Proposal for 07 series of amendments to Regulation No. 16 (Safety-belts, ISOFIX and i-Size)

Submitted by the Working Party on Passive Safety *

07 series of amendments to Regulation No. 16 (Safety-belts, ISOFIX and i-Size)

Model A

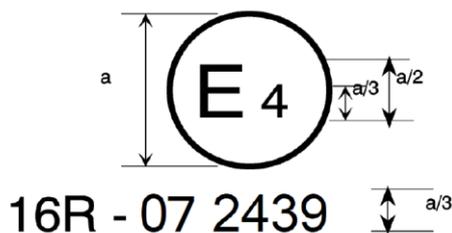
Annex 2, amend to read:

The above approval mark affixed to a vehicle shows that the vehicle type concerned has, with regard to safety-belts, been approved in the Netherlands (E 4) pursuant to Regulation No. 16. The approval number indicates that the approval was granted according to the requirements of Regulation No. 16 as amended by the 07 series of amendments.
